**Planning application no: 2021/94552**

**Land at, Barnsley Road, Denby Dale, Huddersfield HD8 8TS.**

**Erection of 53 dwellings and associated works**

**Comments for inclusion in the public consultation relating to the above planning application.**

Drawing Title:  
**250 Engineering Feasibility Layout**

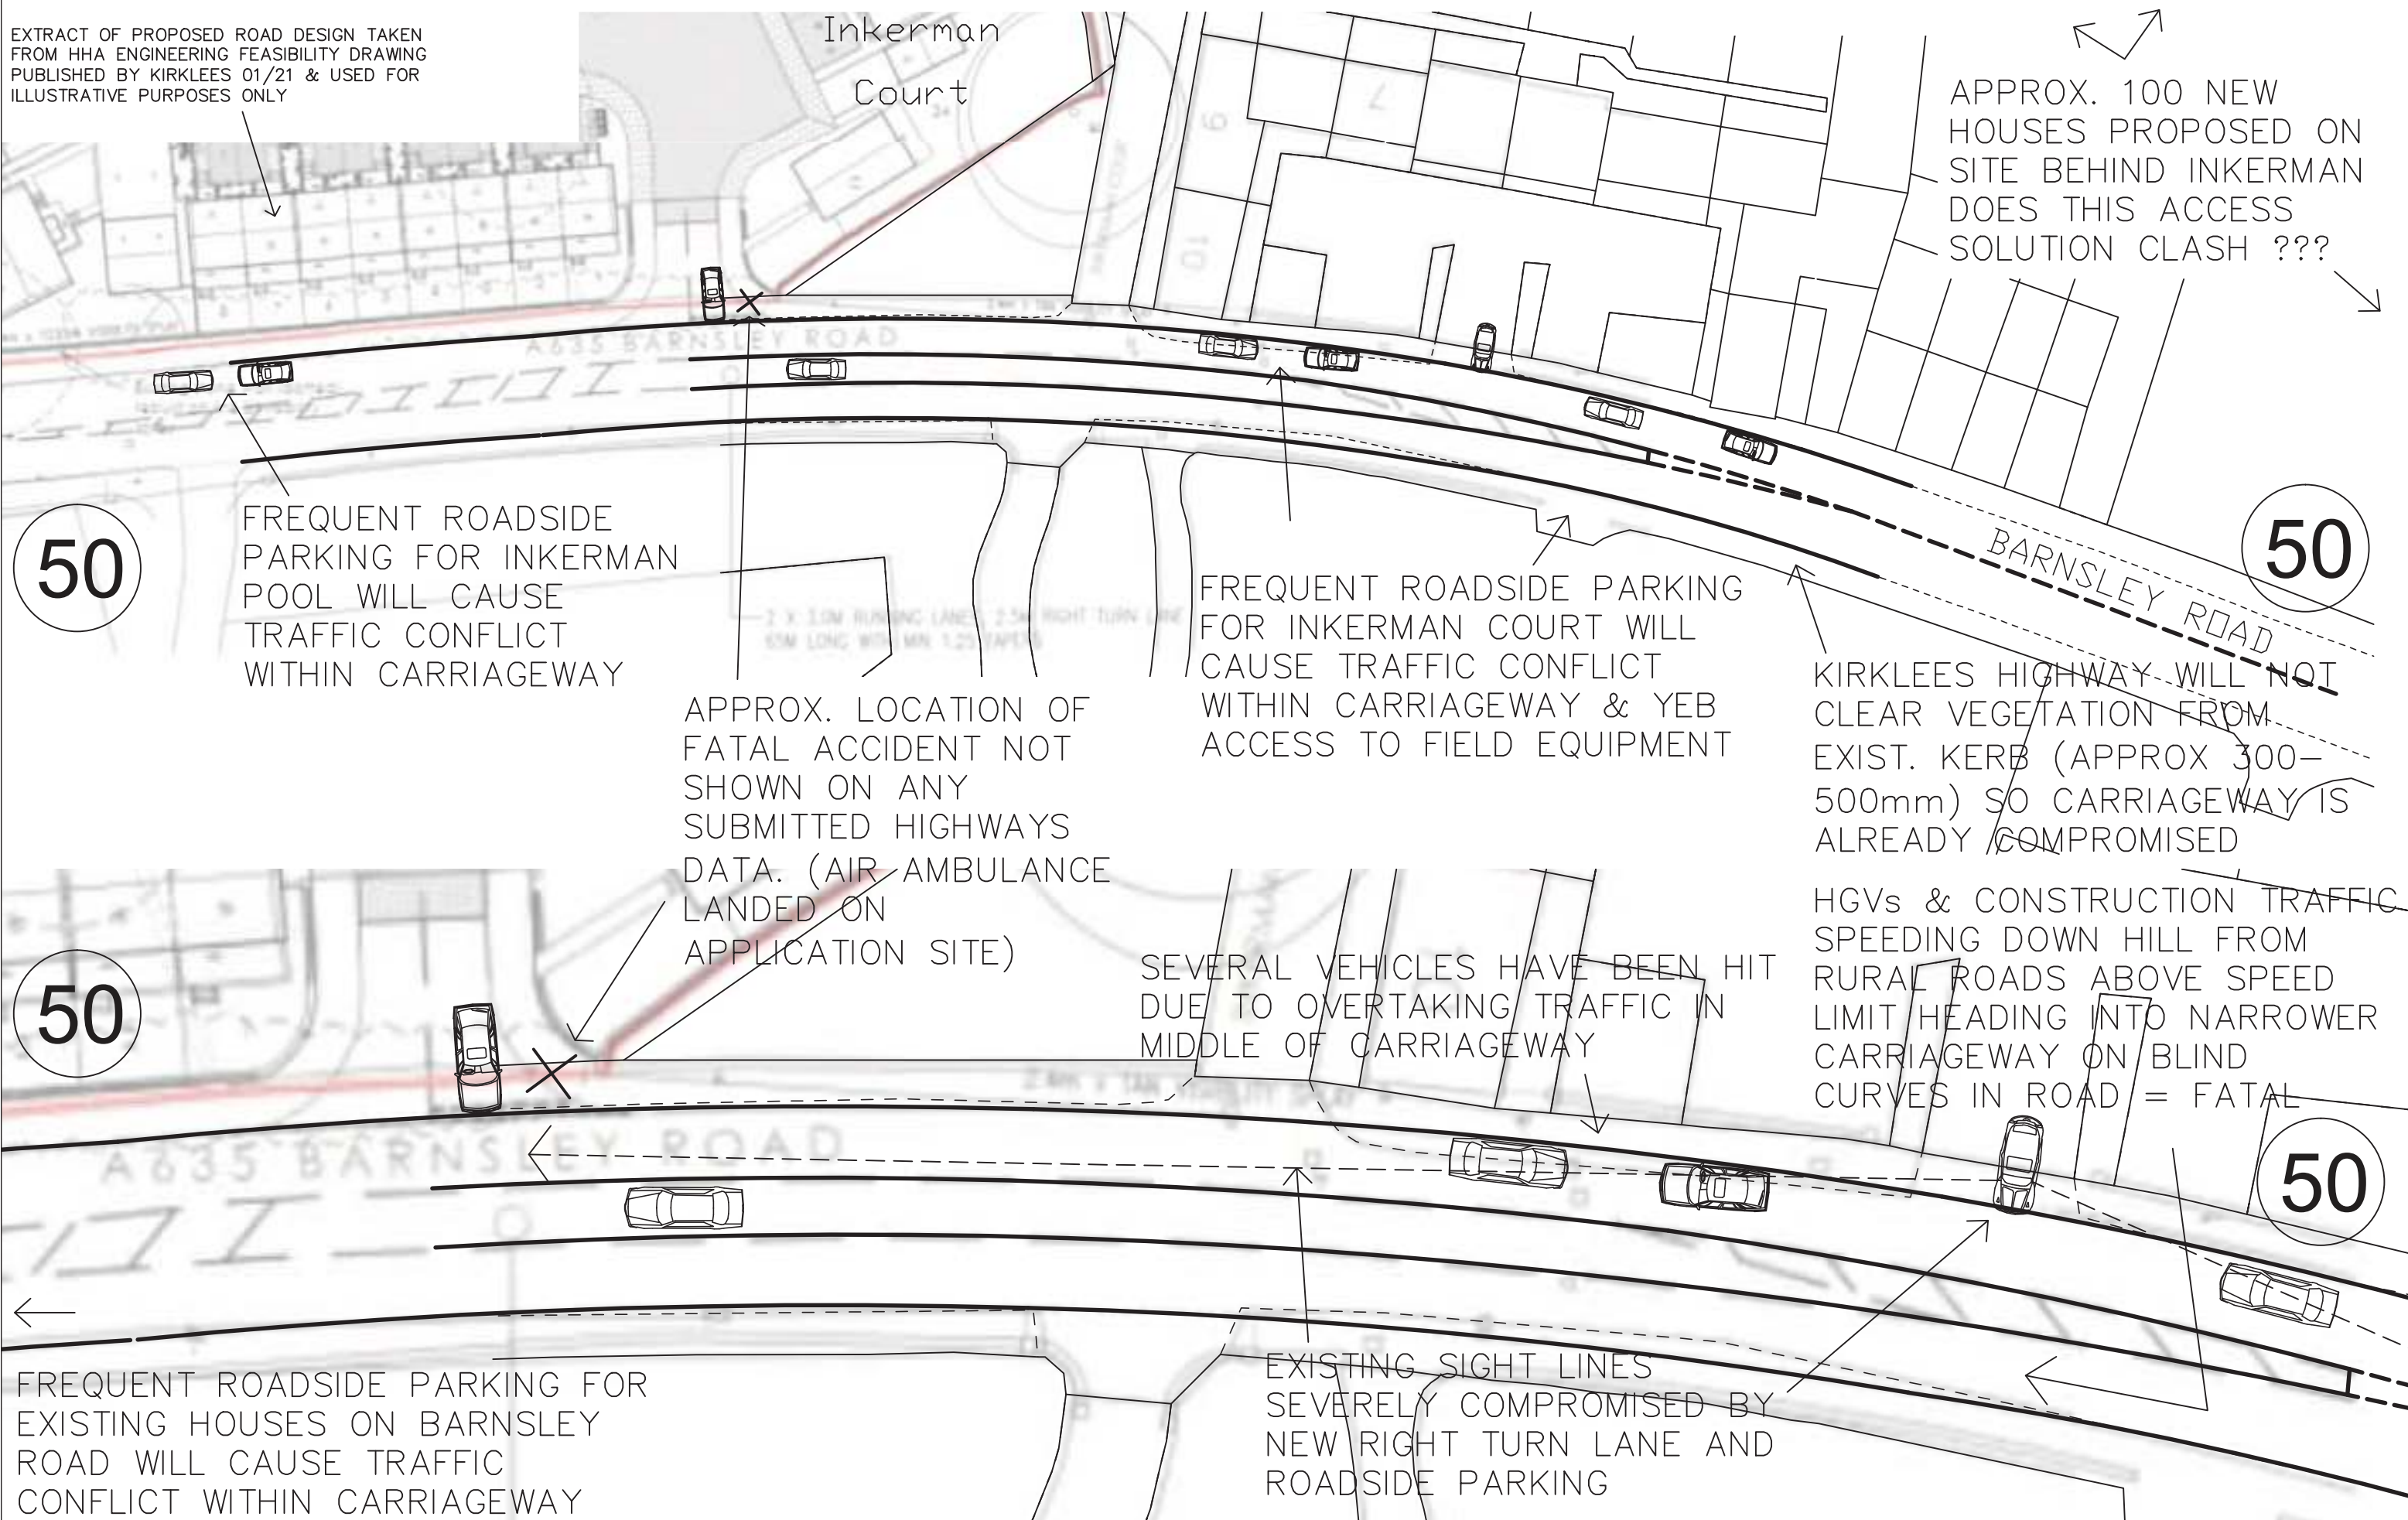
Unacceptable tolerance especially after doing site detailed ground survey and pre-planning

EXTRACT OF PROPOSED ROAD DESIGN TAKEN FROM HHA ENGINEERING FEASIBILITY DRAWING PUBLISHED BY KIRKLEES 01/21 & USED FOR ILLUSTRATIVE PURPOSES ONLY

## Appendix 10: Retaining structures

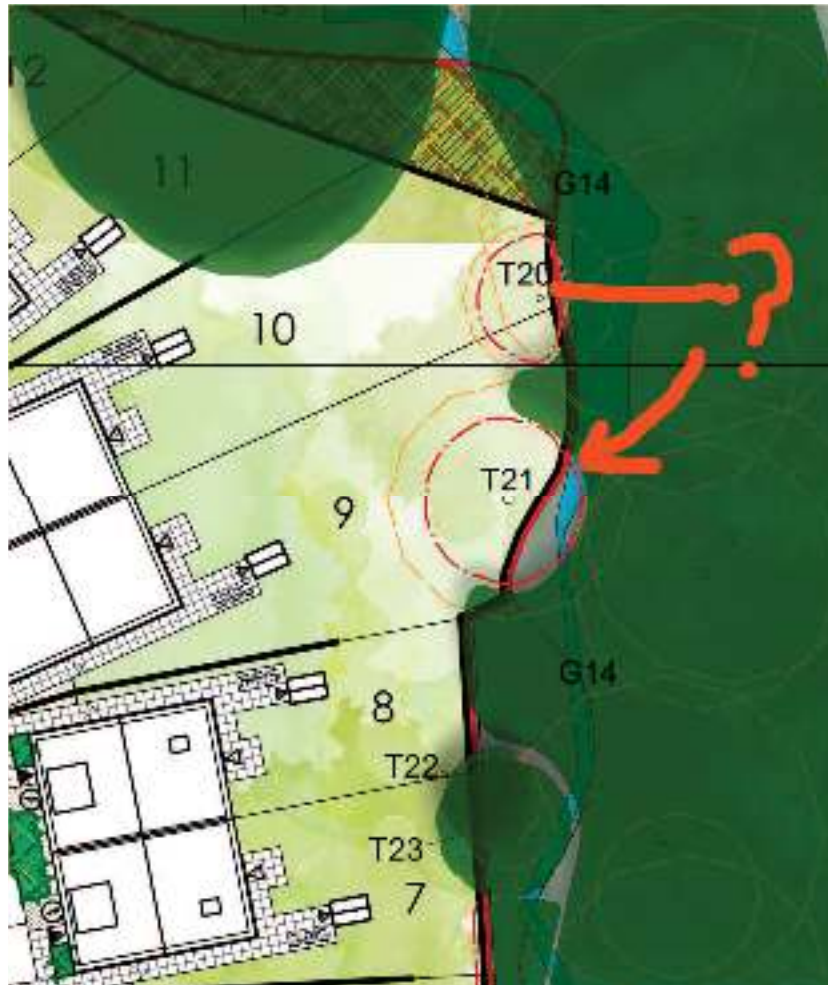
Indeed when looking at the 250 Engineering Feasibility drawing, retaining structures are shown and there is no detail of these included within the application so we must insist that these are provided as a matter of urgency to determine the severity of overlooking on the Inkerman Way properties. See Appendix 10.

## Appendix 11: Tanner Wood issues

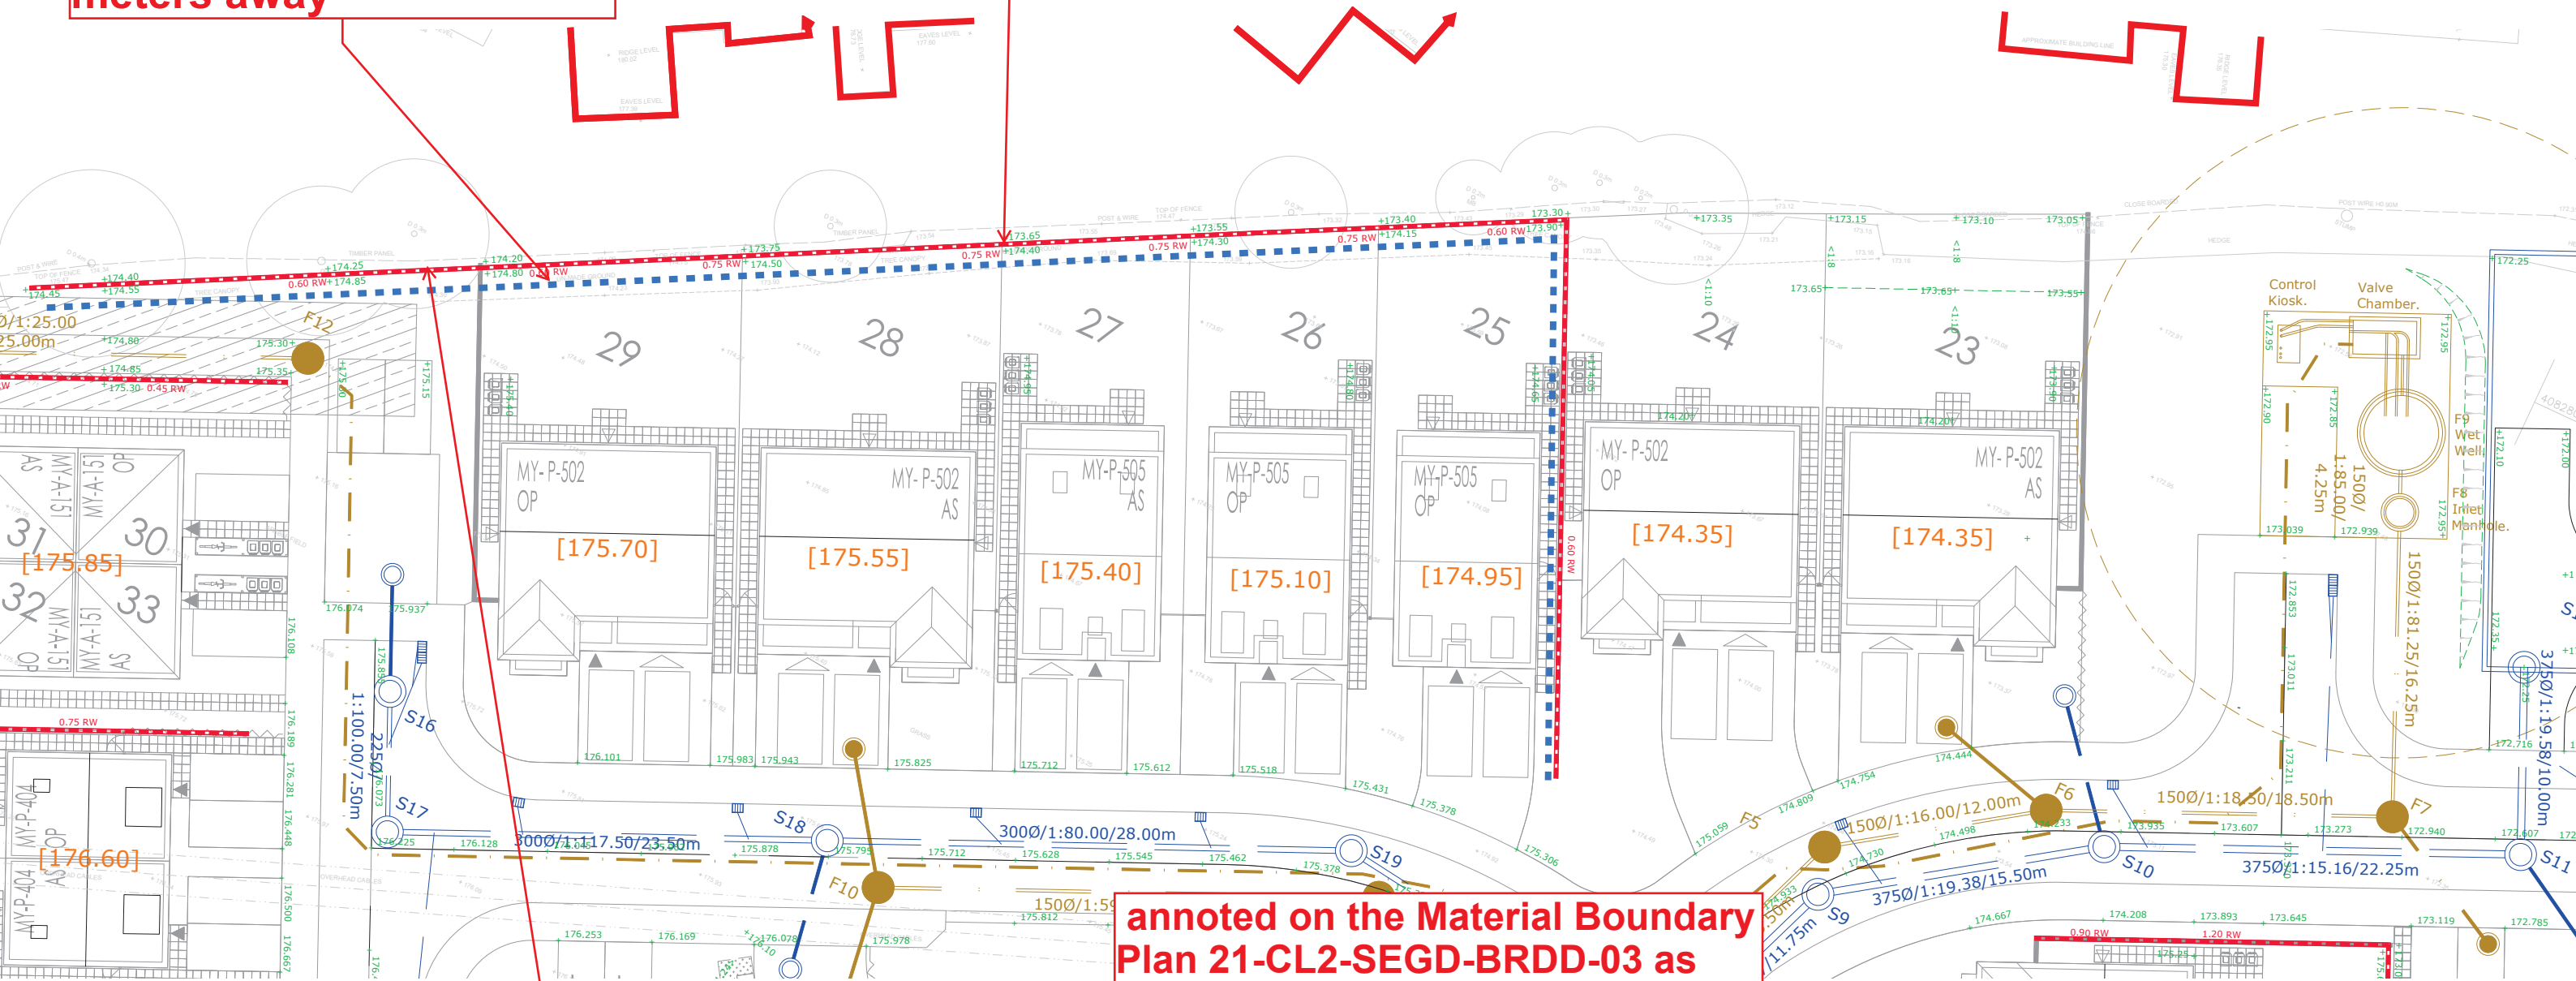
Kirklees TPO map, **Tanner Wood** There is a protection order on this area. ID DD2/51/w28

**WHY are these trees being removed ?** Extract from Submitted Landscape drawing P20-1107.001 Rev B

This is an area north of the site
